## ADDENDUM #2

Date: 07/01/2024

Project: Reroofing Project for the  
Merrillville Community School Corporation  
6701 Delaware Street  
Merrillville, Indiana 46410  
Architect's Project # 24013

SHEET  
A  
3.1.0

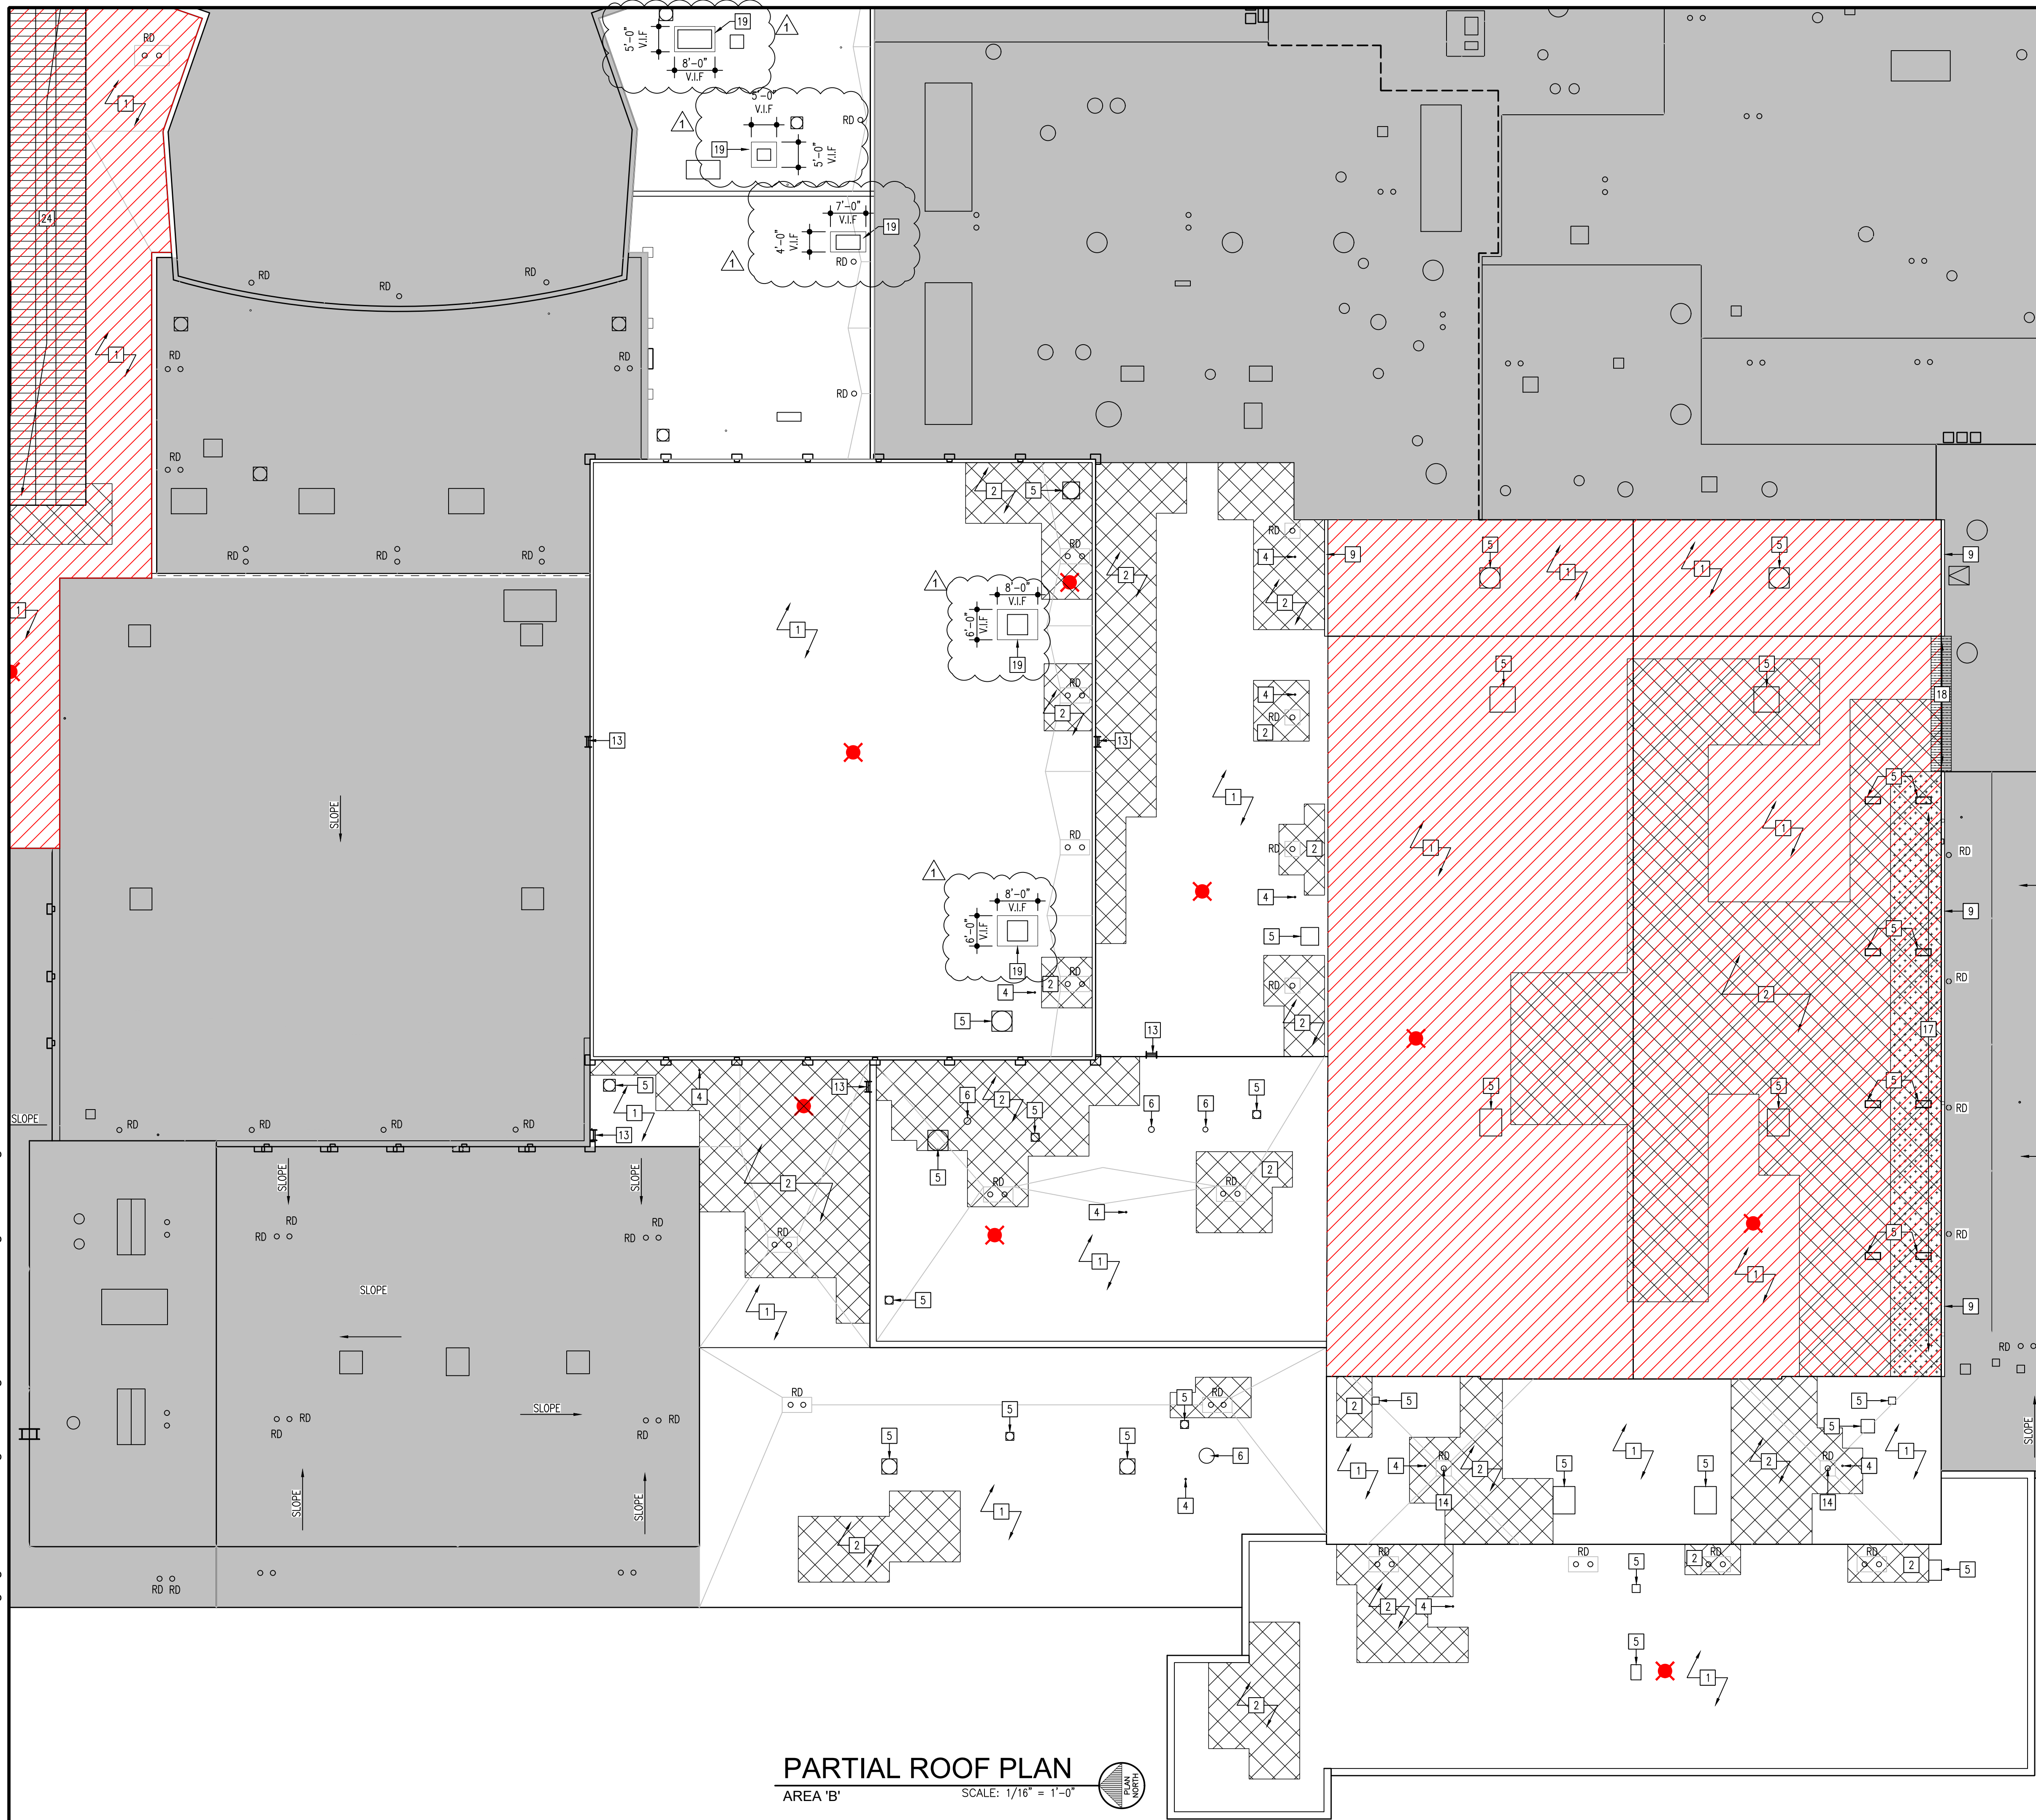
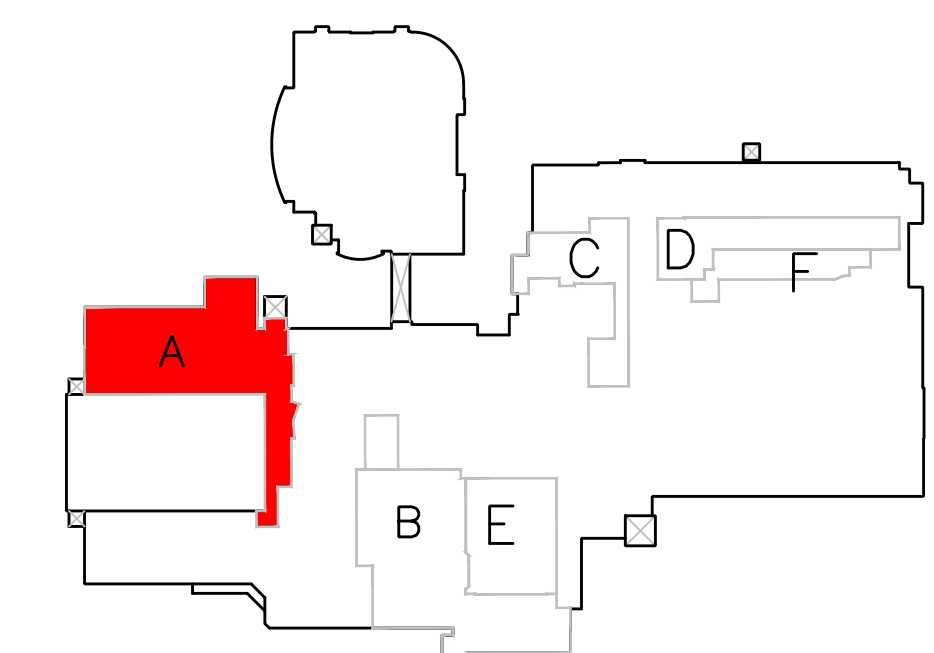
3. See attached Revised Drawing Sheet A3.1.0 – Partial Roof Plan – Area A – This plan shows clouded and tagged revisions dated 07/01/2024.
4. See attached Revised Drawing Sheet A3.1.1 – Partial Roof Plan – Area B – This plan shows clouded and tagged revisions dated 07/01/2024.

SHEET  
**A**  
3.1.3

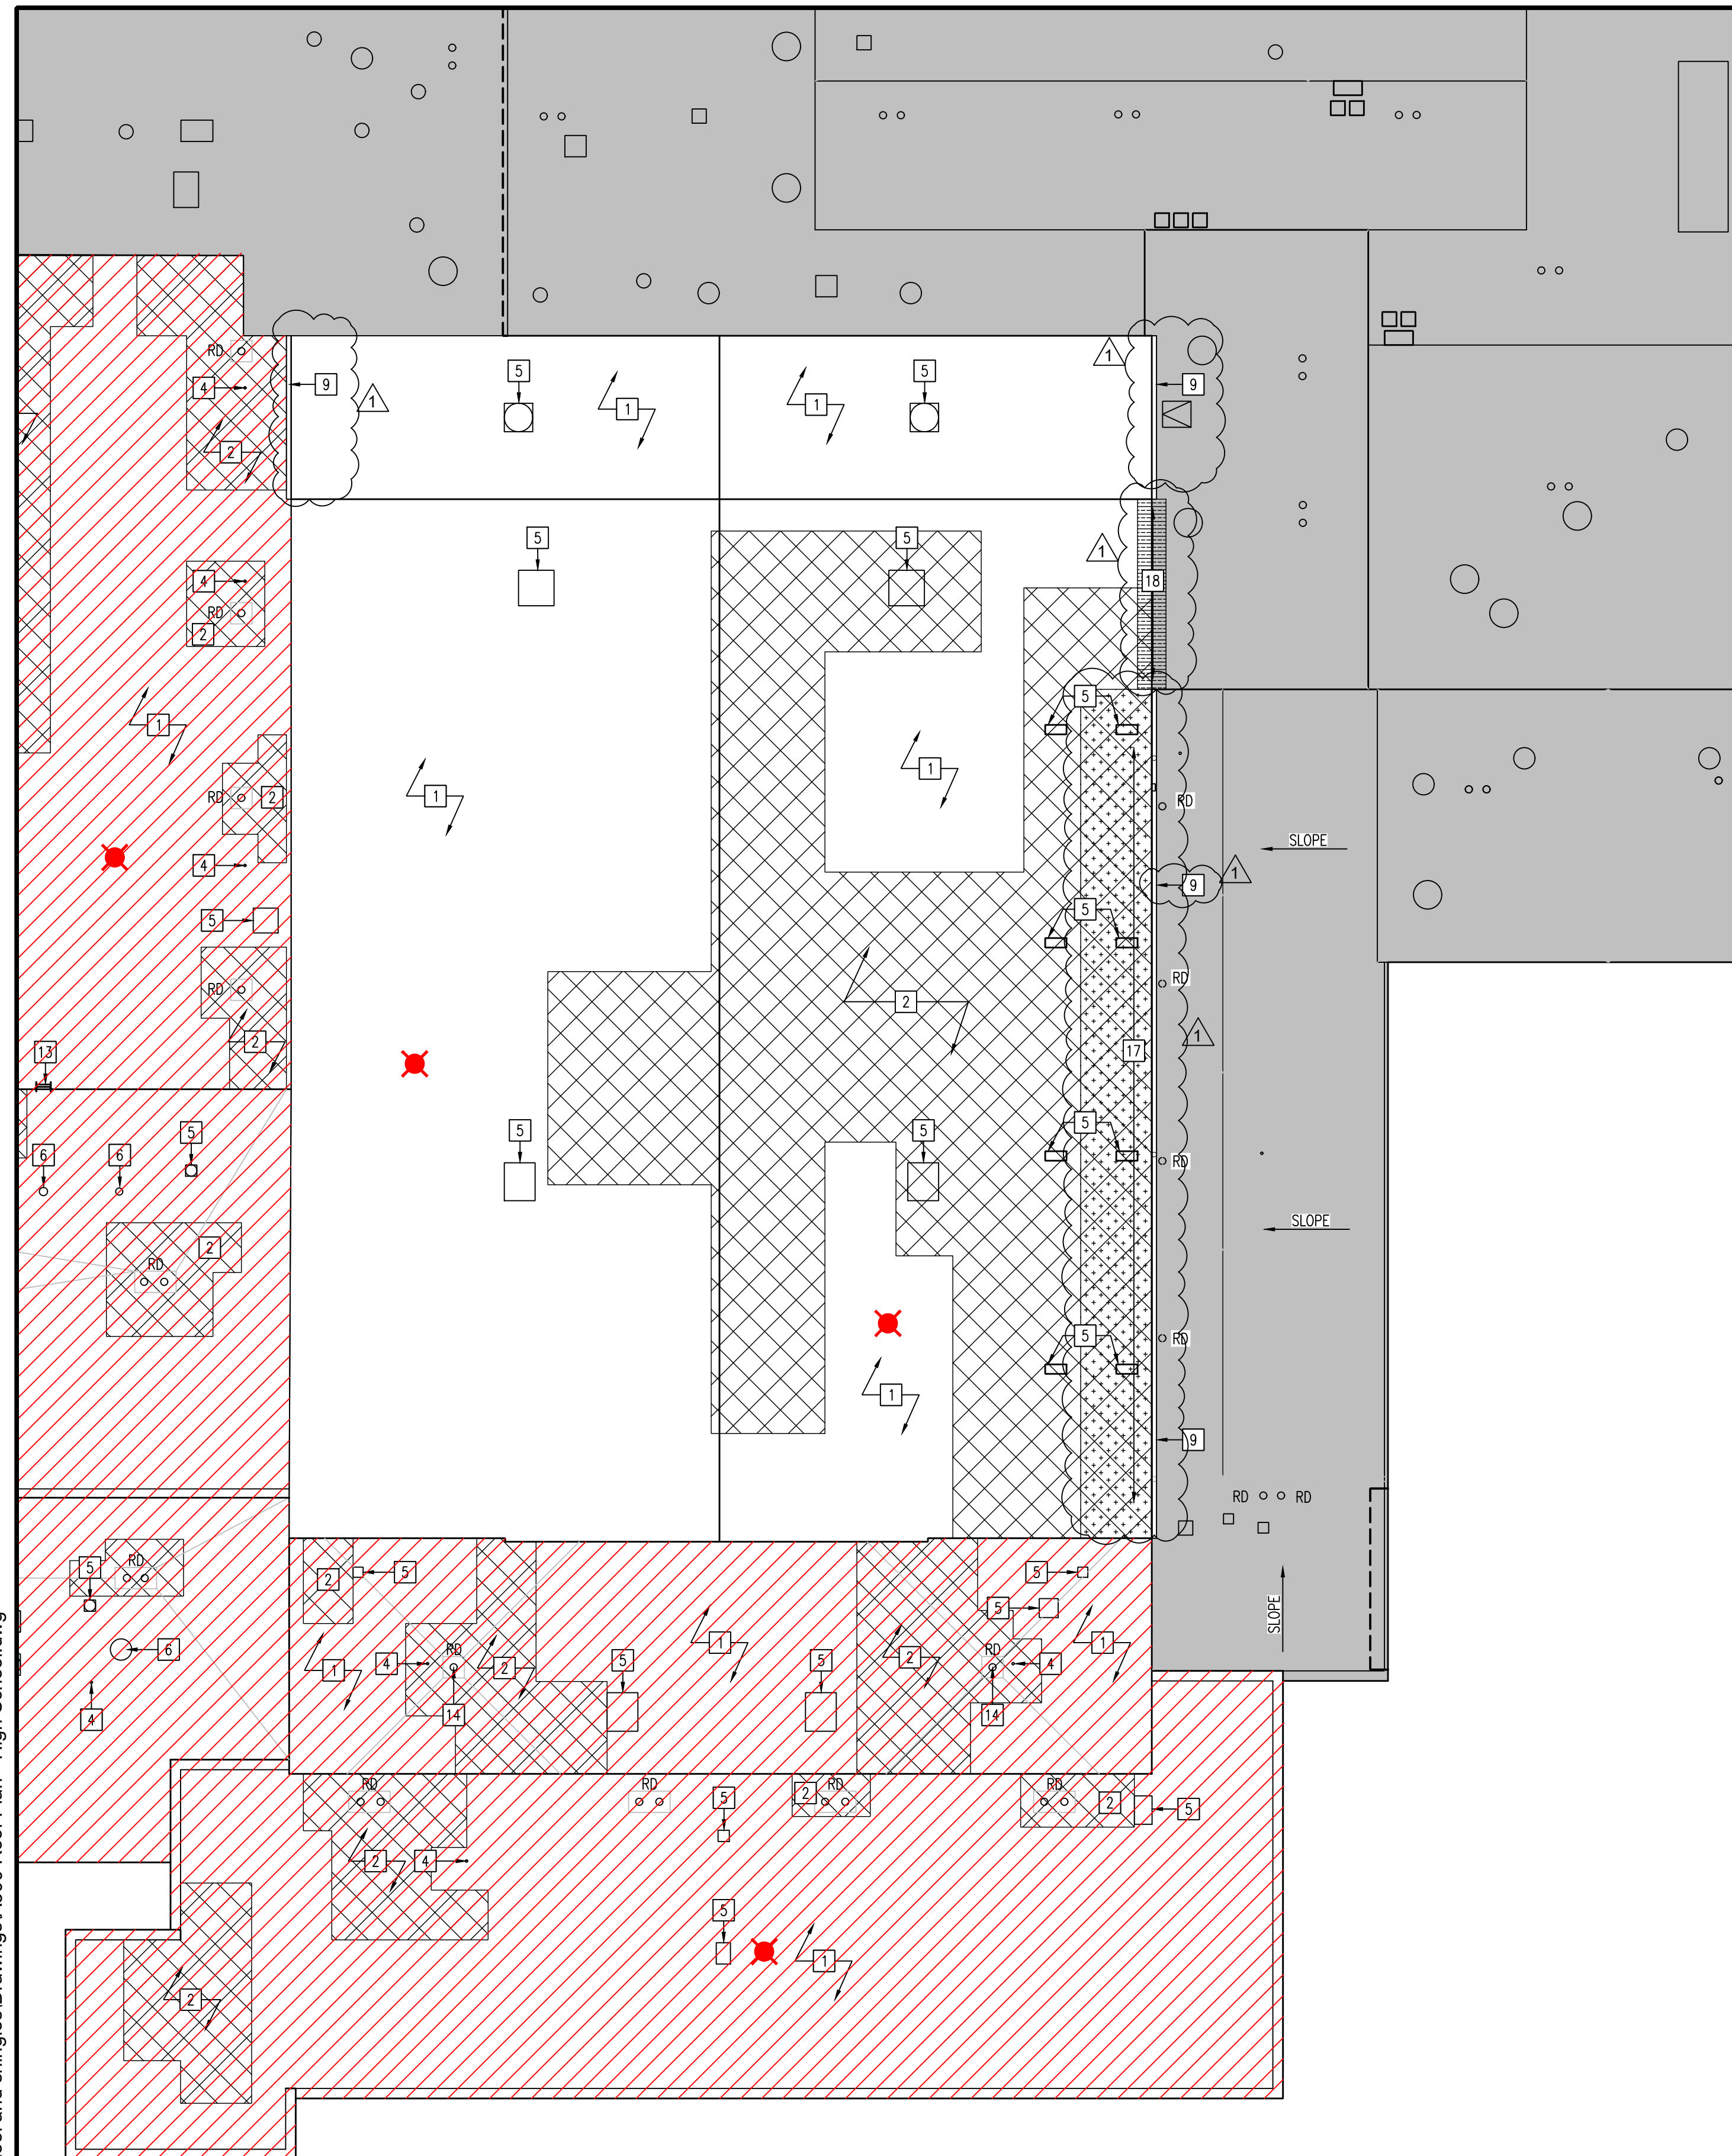
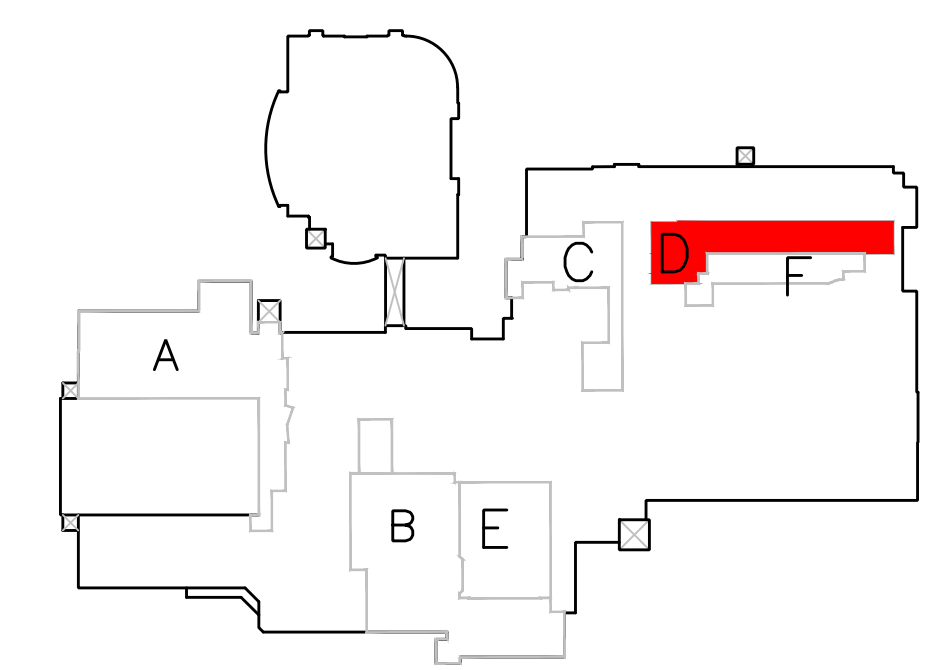
5. See attached Revised Drawing Sheet A3.1.3 – Partial Roof Plan – Area D – This plan shows clouded and tagged revisions dated 07/01/2024.
6. See attached Revised Drawing Sheet A3.1.4 – Partial Roof Plan – Area E – This plan shows clouded and tagged revisions dated 07/01/2024.
